# Supporting materials for 802.3dj D2.0 comment #460

Jeff Slavick - Broadcom

### **73.4.3 Transmit Switch function**

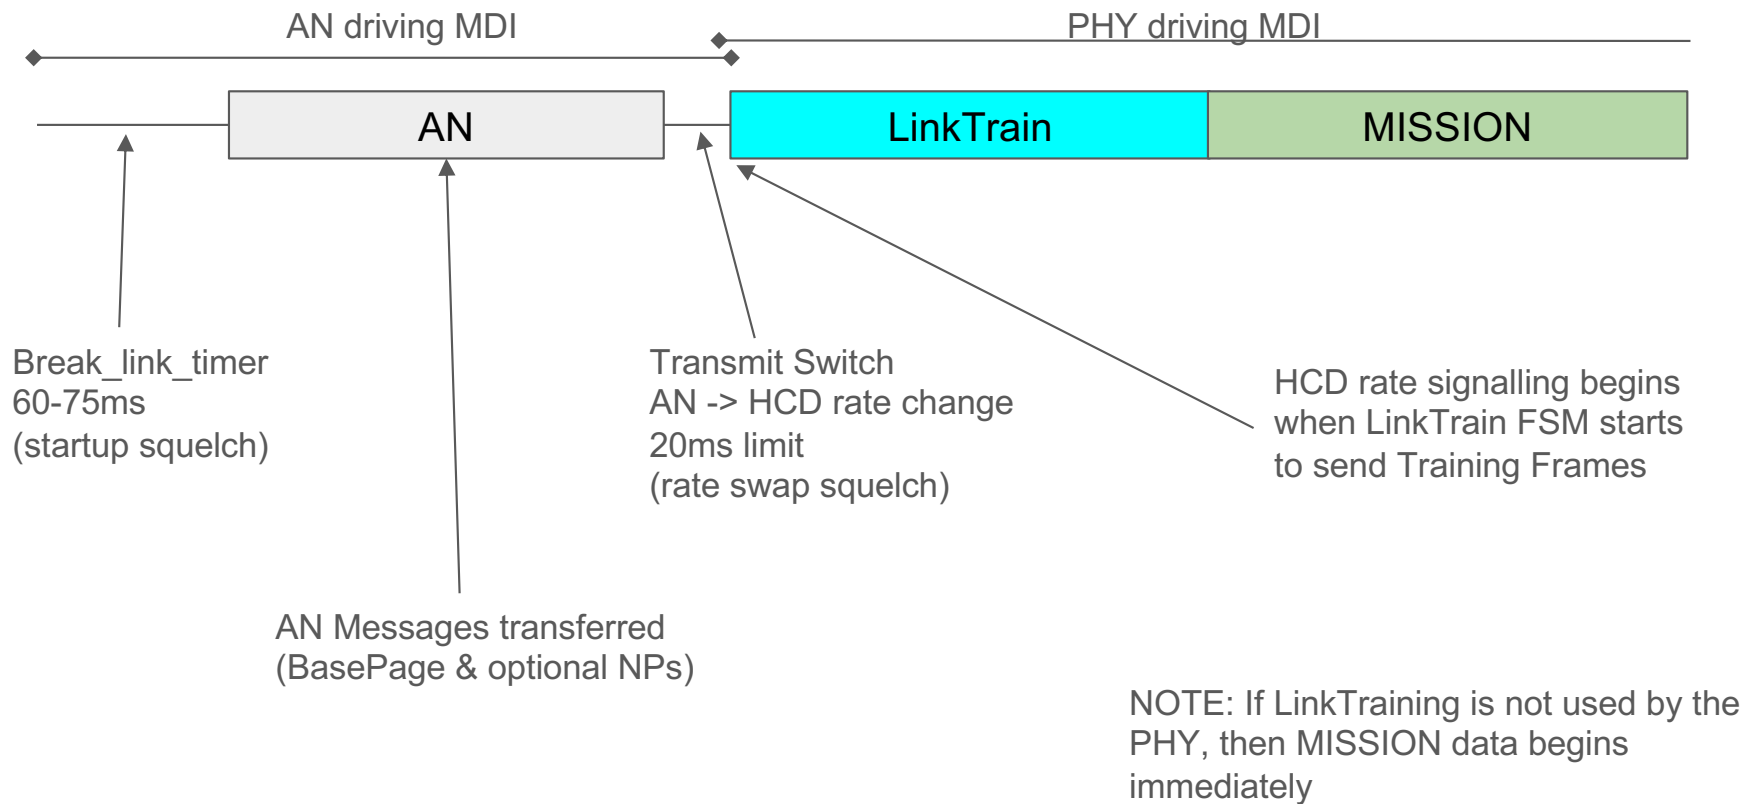
When a PHY is connected to the MDI through the Transmit Switch function, the signals at the MDI shall conform to all of the PHY specifications within 20 ms.

The time limit was added in 802.3bj when 25G NRZ data rates were added and SerDes began to potentially need to change VCO configurations to swap between AN mode and HCD rates. Depending upon the design this could be quick or very slow. So a time limit was established to bound implementations and provide interop expectations.

Change 73.4.3 to read as follows:

When a PHY is connected to the MDI through the Transmit Switch function, the signals at the MDI shall conform to all of the PHY specifications within 20 ms unless the PHY is using the Clause 178B Inter-sublayer link training, then it shall conform within 250ms.

Figure 178B-8 exert (200Gbps PAM4)

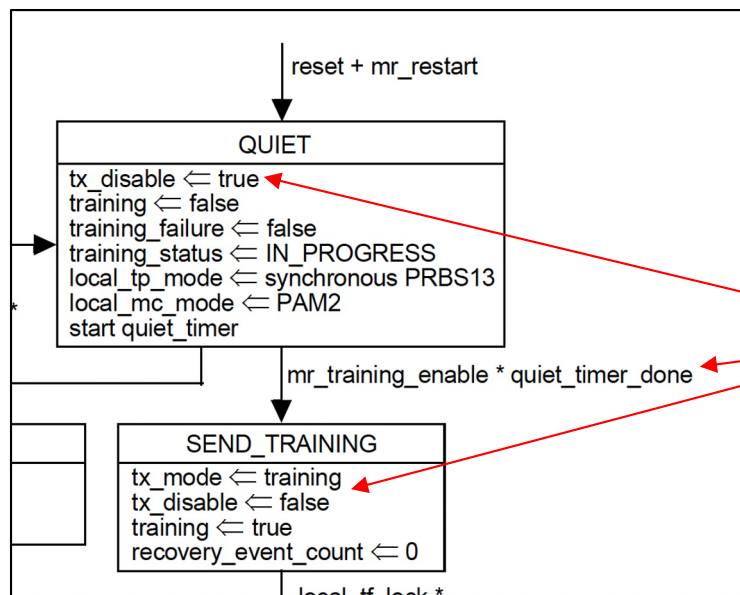
Frames begin transmission after reset removal when mr\_training\_enable = 1 and quiet\_timer expires (100-200ms)

Update the duration of the 178B quiet\_timer so that during AN startups ILT doesn't do an extremely long squelch at startup.

In 178B.14.3.3 change the definition of the quiet timer to be:

quiet\_timer

This timer is started when the training control state diagram on a lane enters the QUIET state (see Figure 178B–8). The terminal count of this timer is between 100 ms and 200 ms **except when an\_in\_use is TRUE, then the terminal count is between 1ms and 10ms.**

Option 2 is the better approach in my opinion.

The quiet\_timer at the start of ILT is there to facilitate non-AN link startup methods. AN already includes a long squelch during its startup process to communicate a (re)start of the startup process and transition from the AN data to HCD data is aligned by the AN FSM. So a long delay to transition from AN data to LinkTrain data is not necessary and just artificially slows down the link-up process.
